Hot Springs Village POA
Cedar Creek WWTP Improvements
Project No. 24022

**ADDENDUM NO. 4 TO THE
CONTRACT DOCUMENTS**

**HOT SPRINGS VILLAGE POA, HOT SPRINGS VILLAGE, AR
CEDAR CREEK WWTP IMPROVEMENTS**

JOB NO:
24022
SHEET NO:
195M305

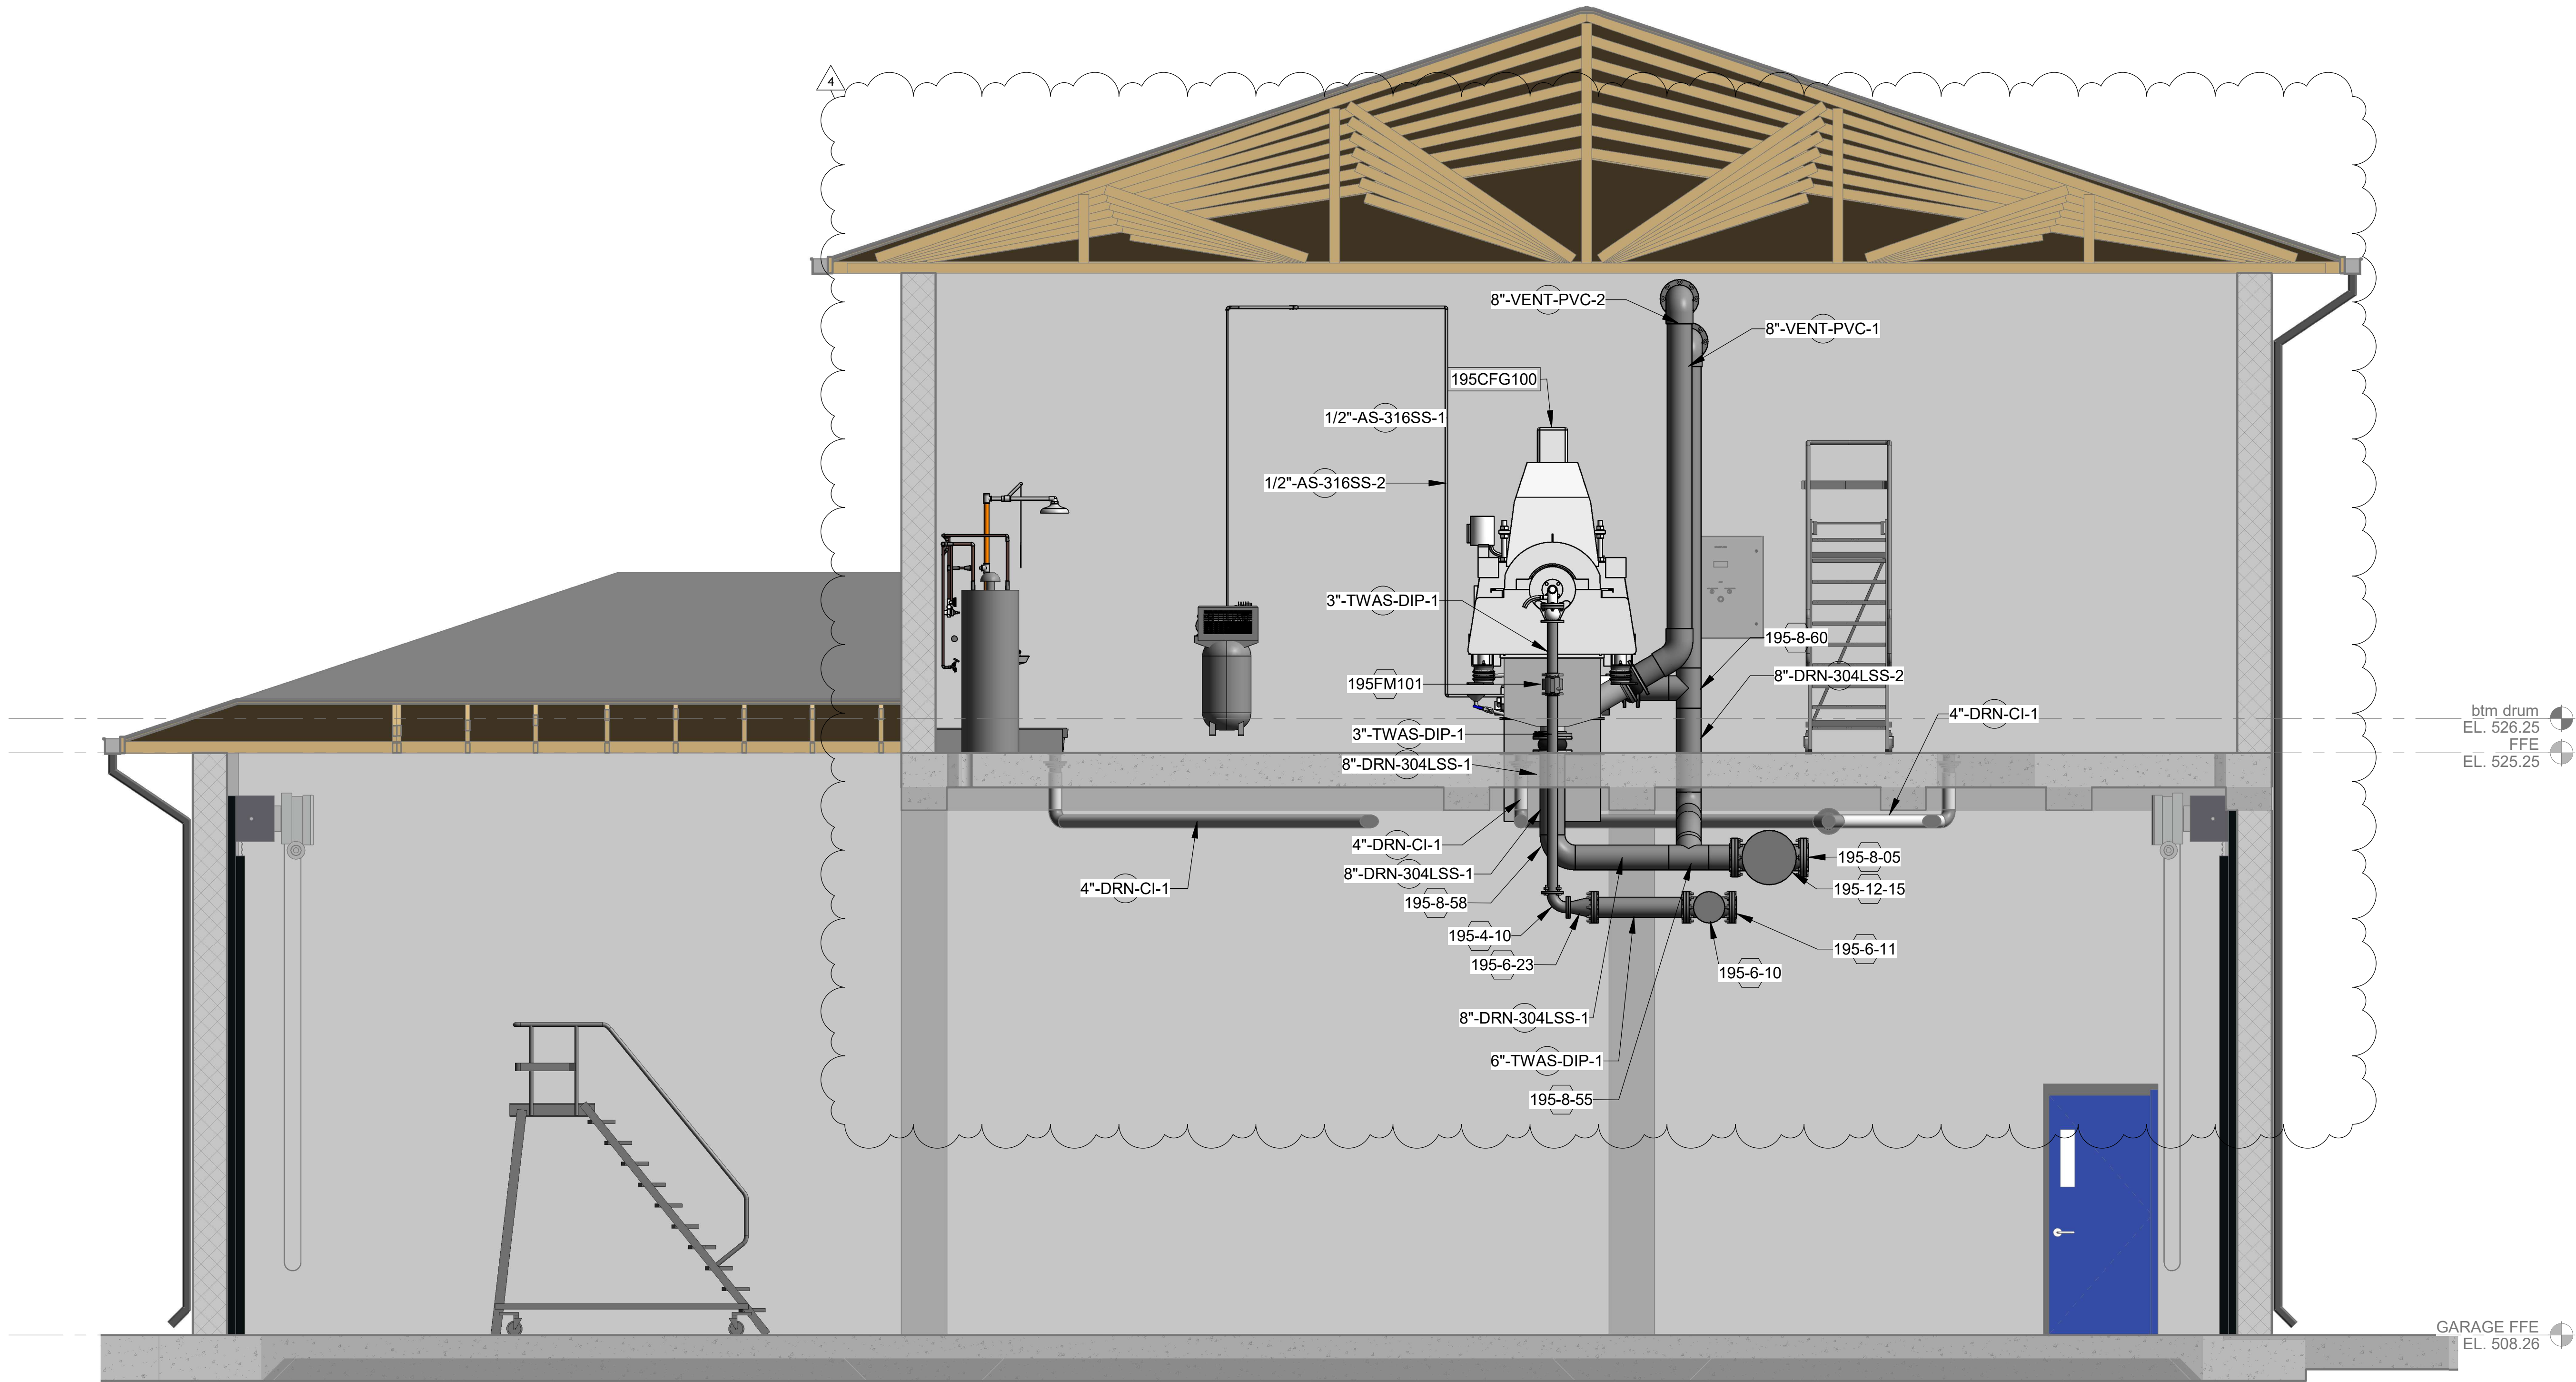
REV. NO.	DATE	DRWN	CHKD	REMARKS
4	5/29/26	MAB	BNW	REVISED PIPING CALLOUTS AND MATERIAL

SHEET NO:

195M600

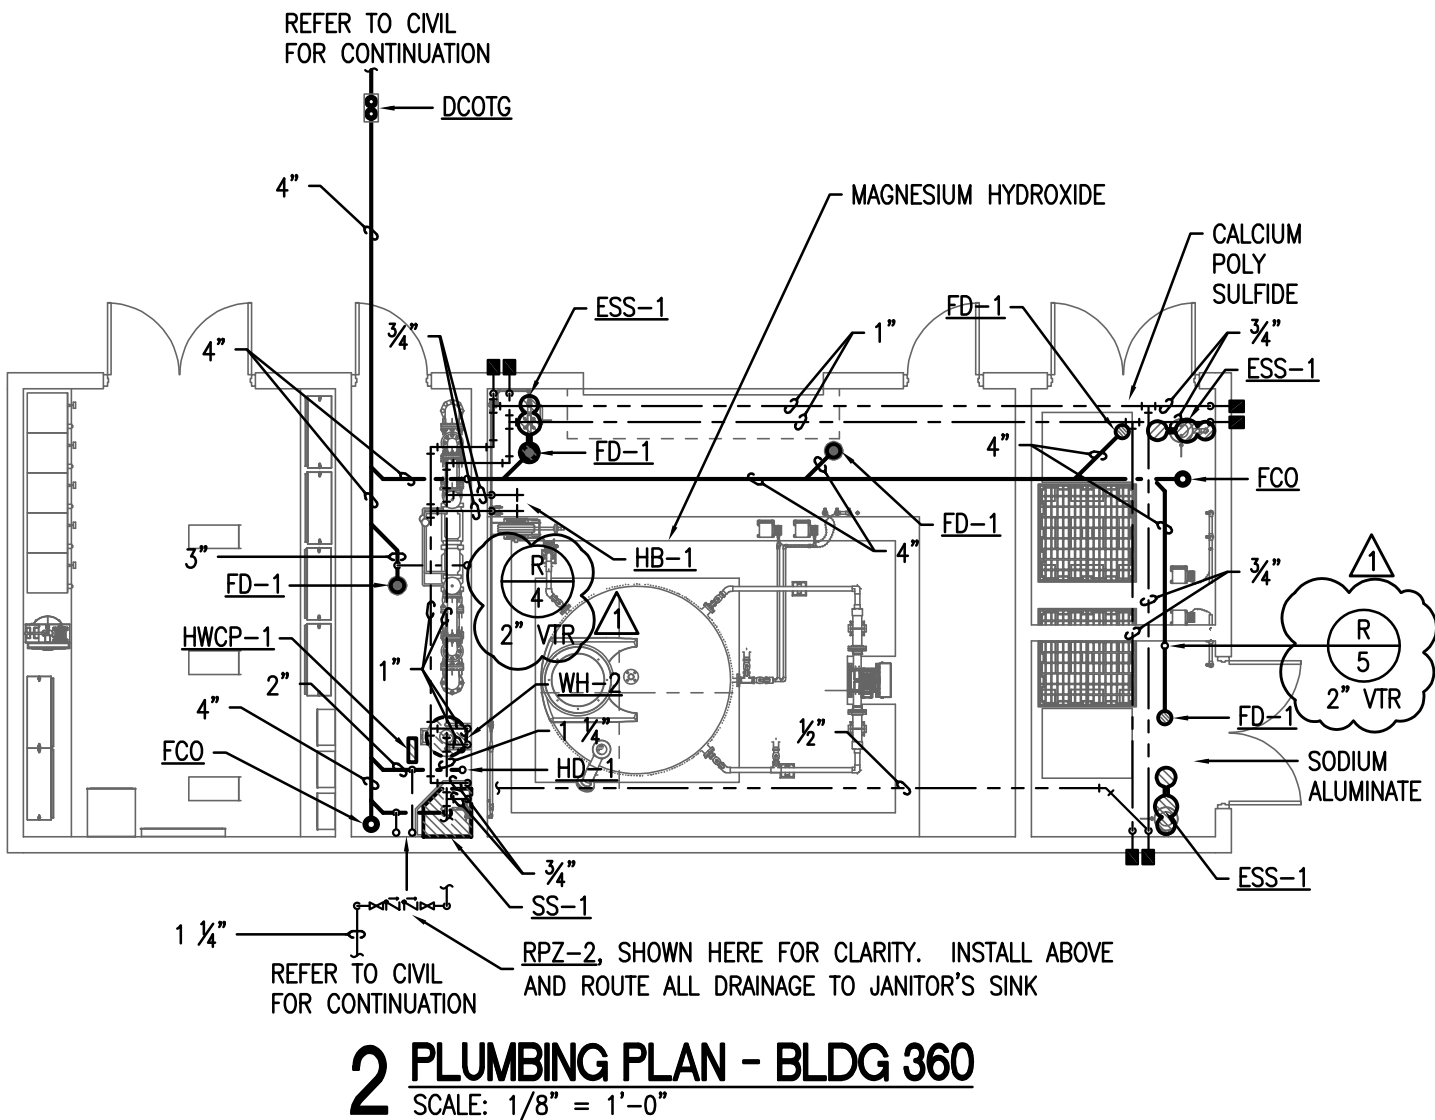
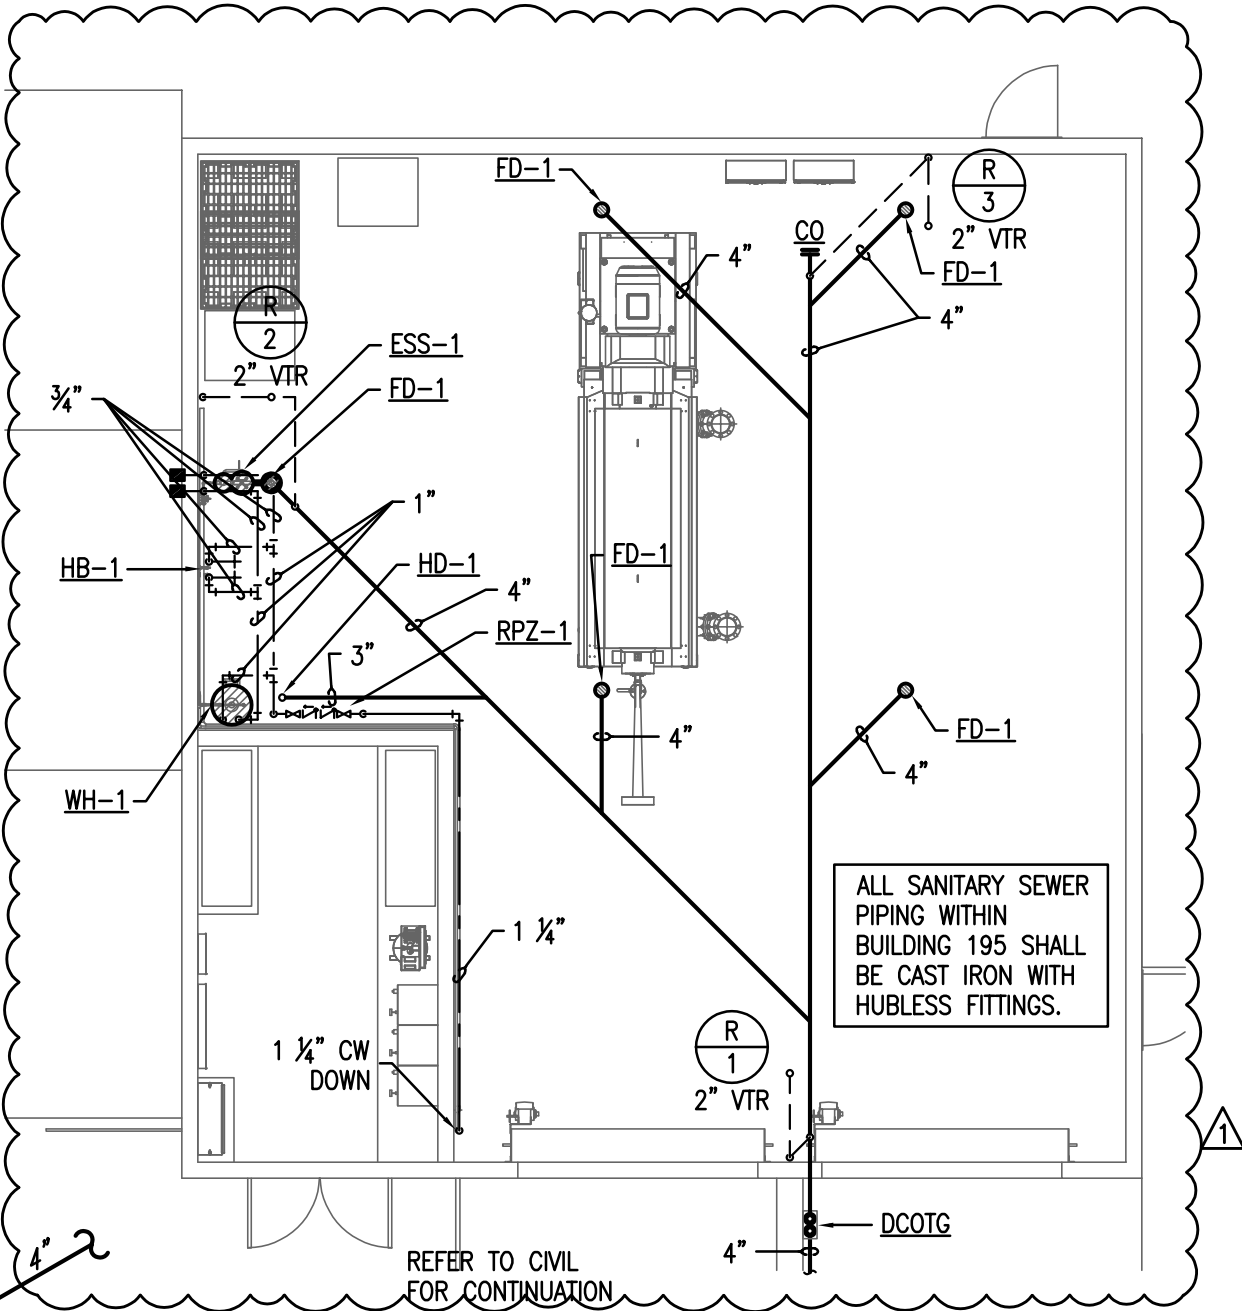
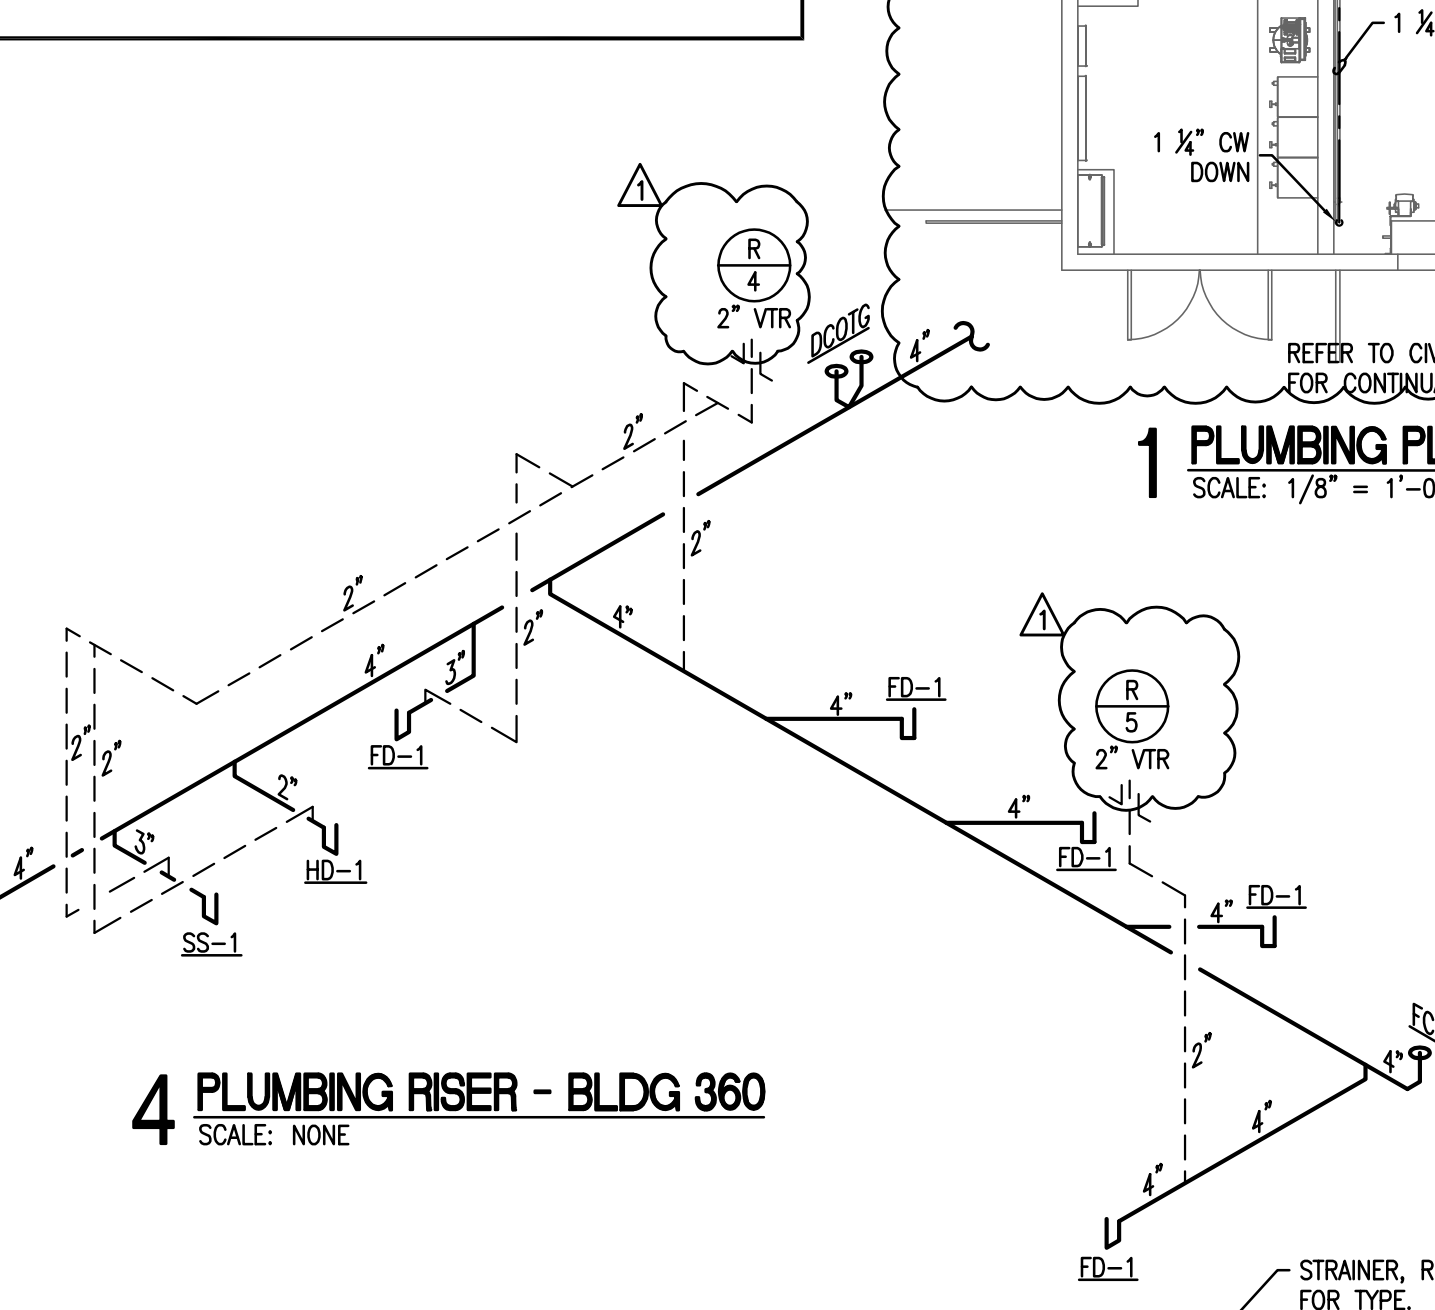
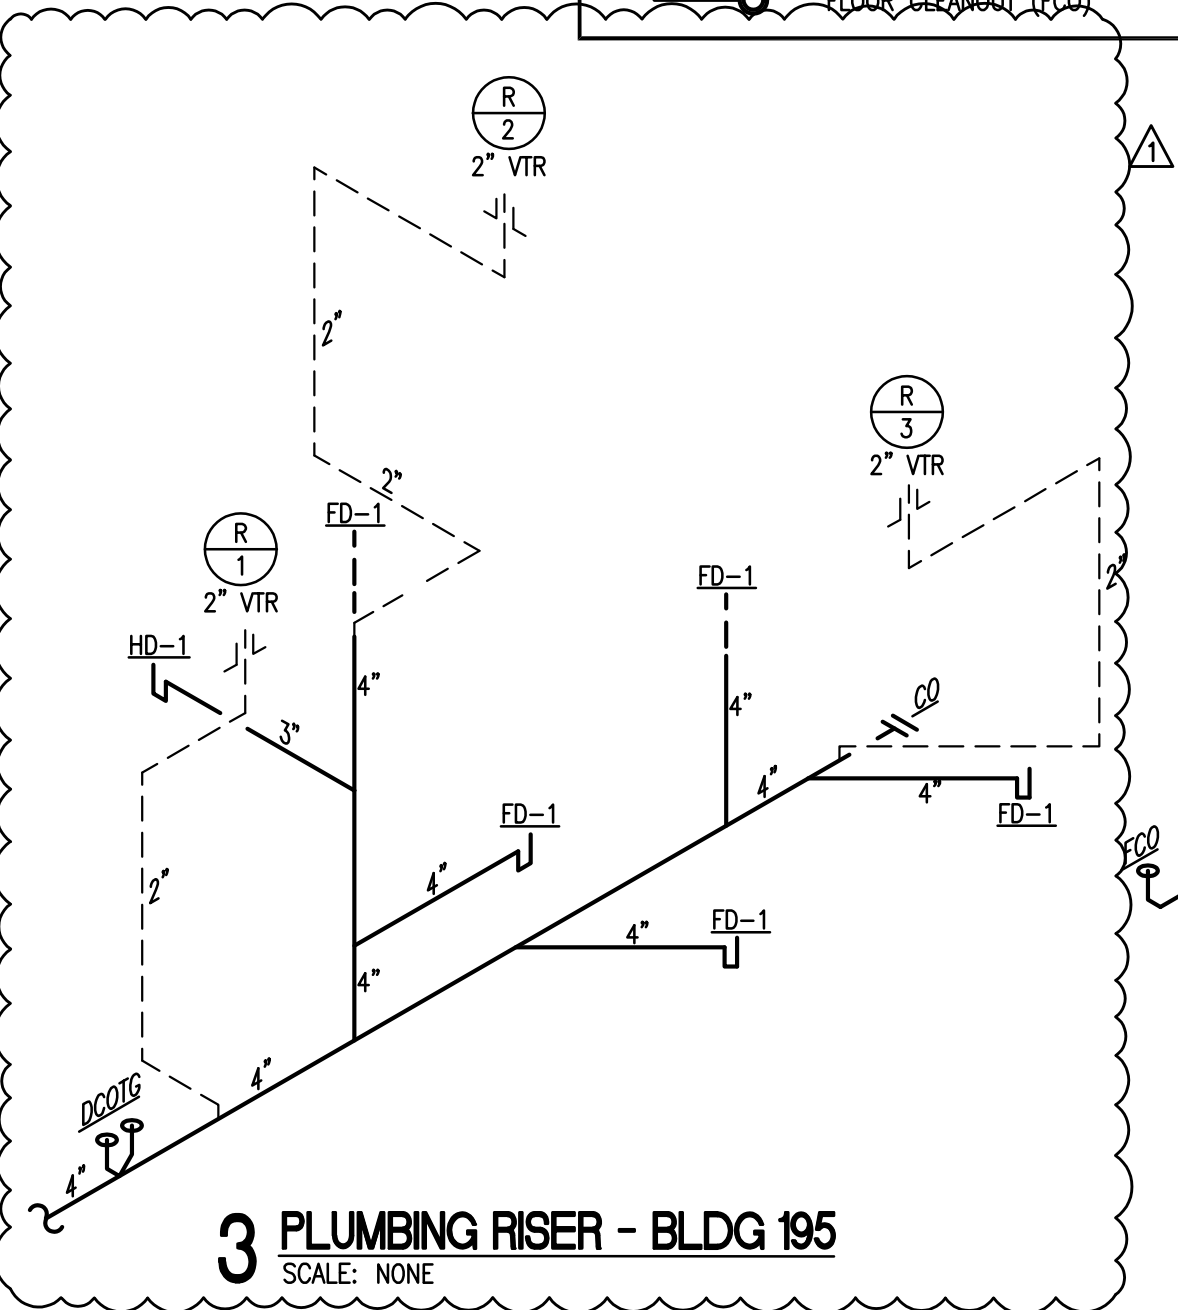
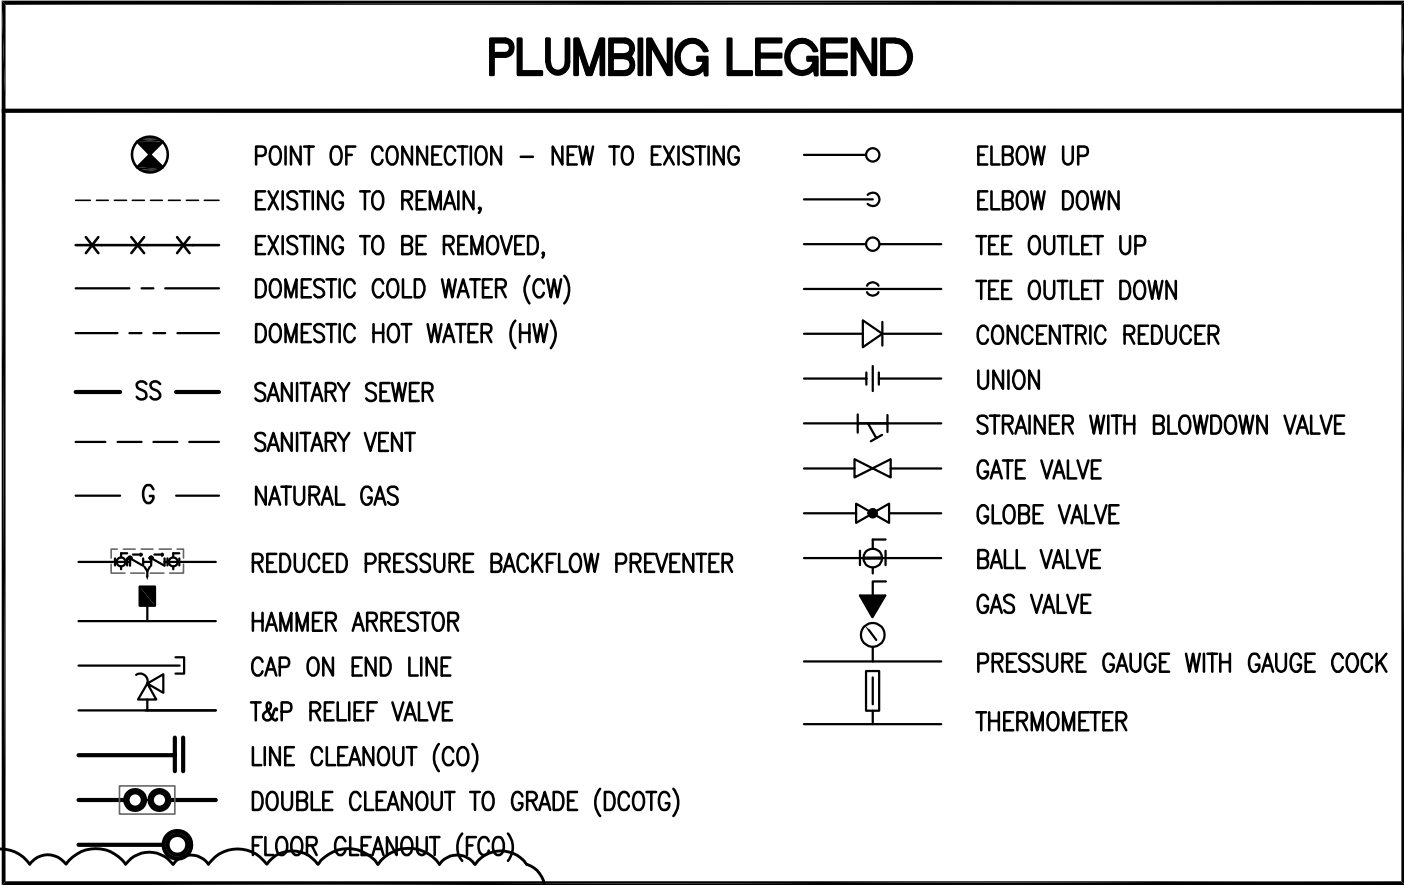
4	5/29/26	MAB	BNW	REVISED PIPING CALLOUTS AND MATERIAL
REV. NO.	DATE	DRWN	CHKD	REMARKS
